Subject: Duke Energy Carolinas, LLC
William States Lee III Nuclear Station - Docket Nos. 52-018 and 52-019
AP1000 Combined License Application for the William States Lee III Nuclear
Station Units 1 and 2
Response to Request for Additional Information Letter No. 122 (eRAI 7573)
Ltr#: WLG2014.08-03

RAI 03.10-4 (eRAI 7573)

NRC Technical Review Branch: **Seismic and Dynamic Qualification of Mechanical and Electrical Equipment**

Figure 5.3-3 Seismic Response Spectra at Containment Operating Floor

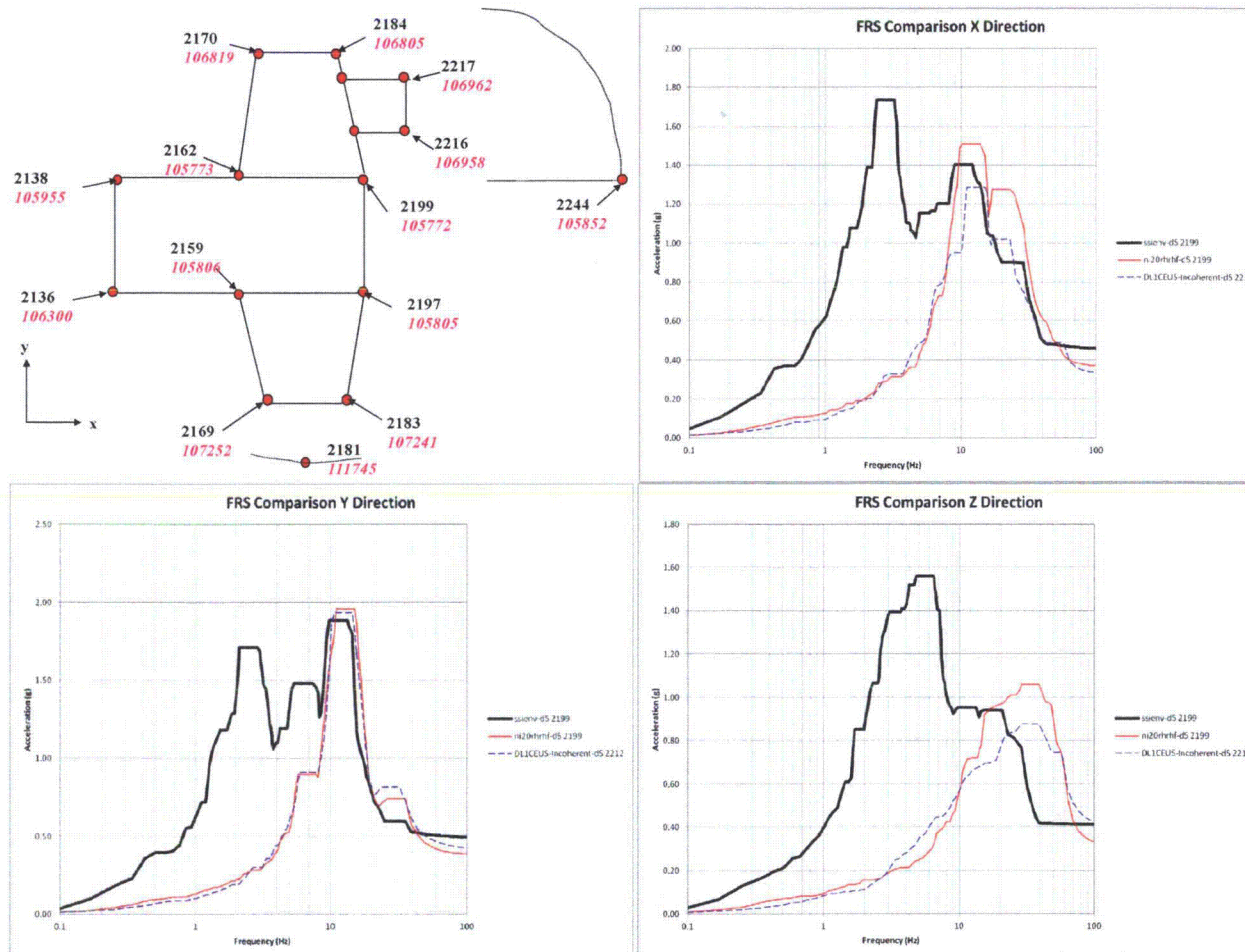
The response to Part (2) of RAI 114, Question 3.10-1 did not address the floor response spectral exceedance between 20 Hz and 30 Hz in y-direction for Node 2212 (Figure 3.7- 210b, Enclosure 2). The applicant is requested to respond to this question in detail, including the impact on equipment affected by this frequency range. This information is needed to address all the potential instances of the floor response spectral exceedance for the WLS station.

Reference 1, Duke Energy's response to Part (2) of RAI 114, Question 3.10-1, notes that FSAR Figure 3.7-210b reproduces the Y-direction spectrum shown in Figure 5.3-3 of Westinghouse Report WLG-GW-GLR-815 (Reference 2) for the Containment Operating Floor (one of the six key locations identified in AP1000 DCD Table 3G.4-1). Note that Node 2199 (from the AP1000 generic finite element model) corresponds to Node 2212 (from the site-specific finite element model), and thus Nodes 2199 and 2212 are the same point/location within the Containment Internal Structure (CIS) El. 135 West portion of the model. A convenience copy of Figure 5.3-3 is provided in Attachment 1.

The exceedances in the spectra at this key location (including the node 2212 Y-direction exceedance between 20 Hz and 30 Hz) are addressed by considering a larger sampling of spectra at this elevation in the Containment Internal Structure (CIS) that is actually used in establishing design requirements for SSCs in that area. Figure 5.4-11 of WLG-GW-GLR-815 presents the floor response spectrum (FRS) envelope for the CIS 135 West Group, of which Node 2199 and the Node 2212 are a part. A convenience copy of Figure 5.4-11 is also provided in Attachment 1. Figure 5.4-11 indicates that in the Y-direction for the CIS 135 West Group in the 20 to 30 hertz (Hz) frequency range, the Duke Lee FRS for this group of nodes is enveloped by the AP1000 hard rock high frequency (HRHF) FRS envelope. Therefore there is no exceedance in this frequency range for the CIS 135 West Group envelope.
